Fuel 335 - Plumbing Vent thru Roof

Description

VIN Range Effected

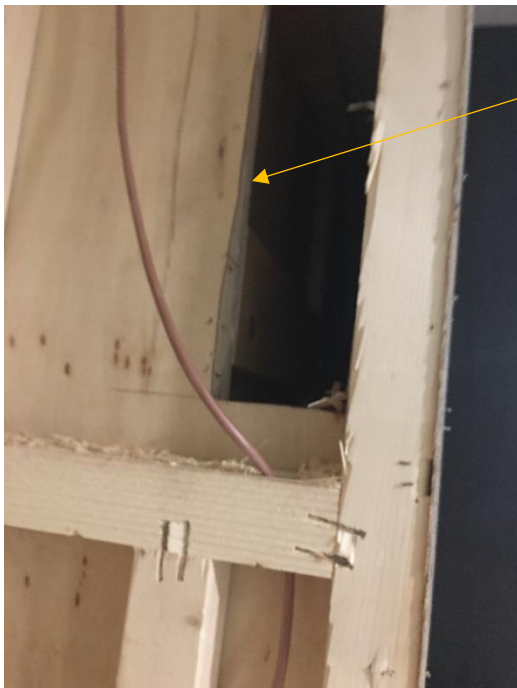
- Remove the wall panel trim on the right side, of the wall panel that is on the right side hall as you go up the stairs into the bedroom.

Remove the trim, as the panel and trim will be re-used be careful not to damage or break the trim.

- Remove the ceiling trim.

Same as with the trim use caution as to not damage the roof trim.
